Technical Bulletin

Product: A/V Receivers

Hardware Technical Bulletin: T743-H2004-02

Date: June 15, 2004 Subject: Flat Ribbon Cables

Figure 1

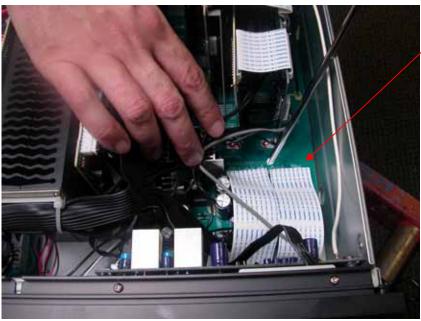
DESCRIPTION: The unit may be experiencing intermittent audio or display. The unit may not always power up.

REASON: The flat ribbon cables, primarily the ones running from the front panel but may include all flat ribbon cables. They may have intermittent contact due to oxidization.

SOLUTION: Clean all ribbon connectors using an eraser or preferably a non alcohol based cleaner which will leave no residue. See figures 1, 2 and 3.

Locate and remove the ribbon cables, front panel cables shown.
